AMENDMENTS TO THE DRAWINGS

Applicant submits replacement third and fourth sheets of drawings (original Figs. 5 and 6) corrected as follows:

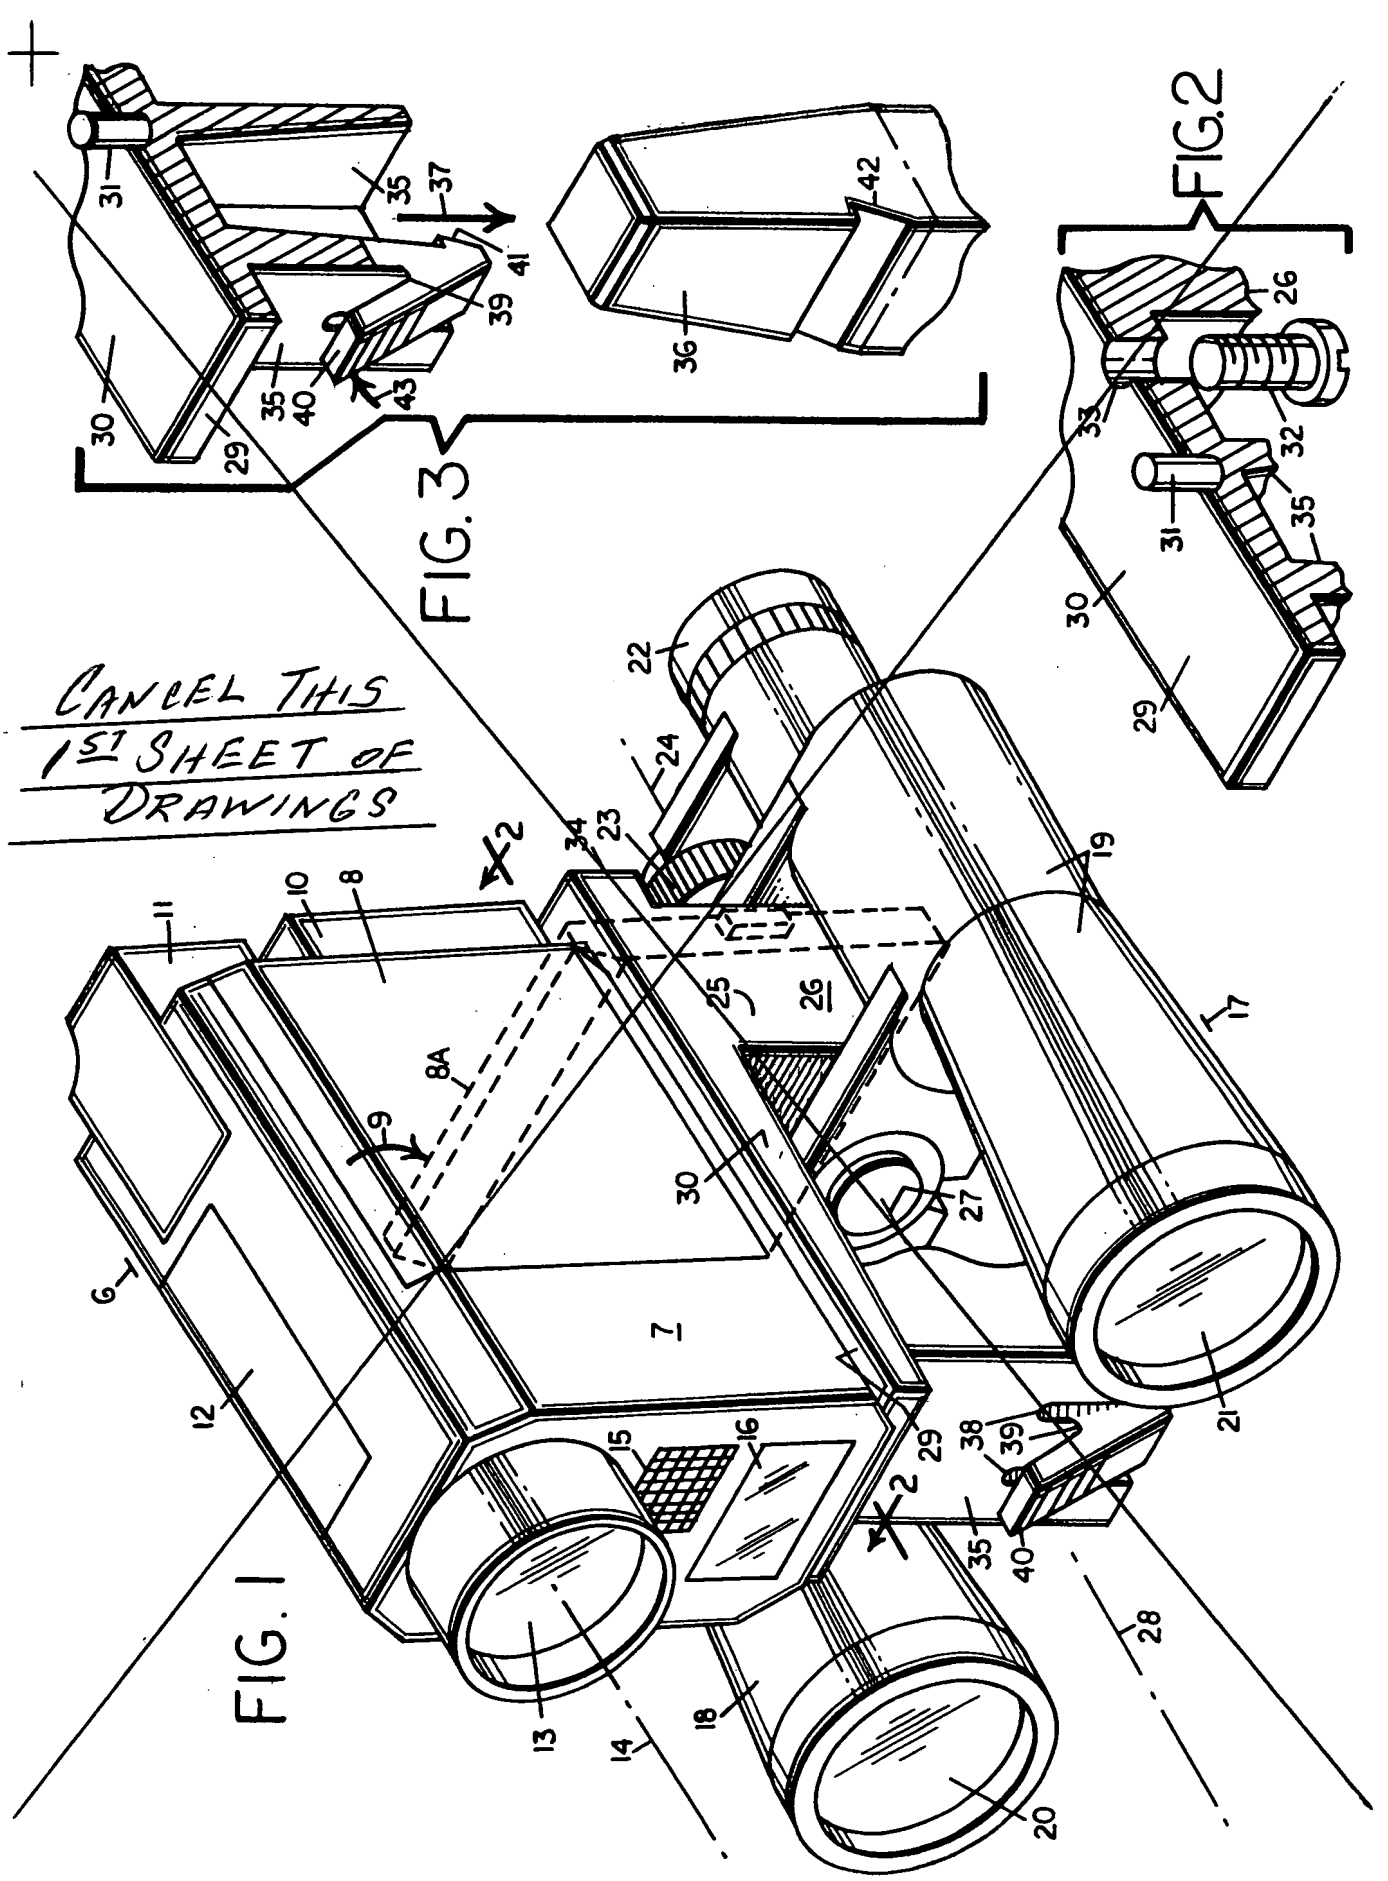
"Fig. 5" (as originally filed) has been changed to "Fig. 1".

"Fig. 6" (as originally filed) has been changed to "Fig. 2".

(a) The original placement of the numeral "44", which appears in both drawings is intended to refer to the "housing" generally . That fact is stated in the specification as originally filed. But the original placement of the numeral "44" is misleading; one must read the specification very carefully in order to understand that the numeral "44" is identifying the housing generally and is not referring to a specific portion of the housing. In the corrected Replacement Sheets, the numeral "44" has been moved to a "stand-alone" location with a "T-shaped" leader that makes it immediately obvious that it is referring to the housing generally.

(b) Figure 5 as originally filed, contains the numeral "44A" which identifies a specific portion of the housing from which a square tube "35" depends for mounting on a tripod (all as described in the specification as originally filed). The square tube "35" is not an essential part of the invention as currently claimed, so there no longer is any need to refer to that specific portion ("44A") of the housing to which the square tube "35" is affixed. Accordingly, in the corrected Fig. 5 (now Fig. 1), the numeral "44A" has been deleted. In order to avoid major alteration of the drawings, as would be
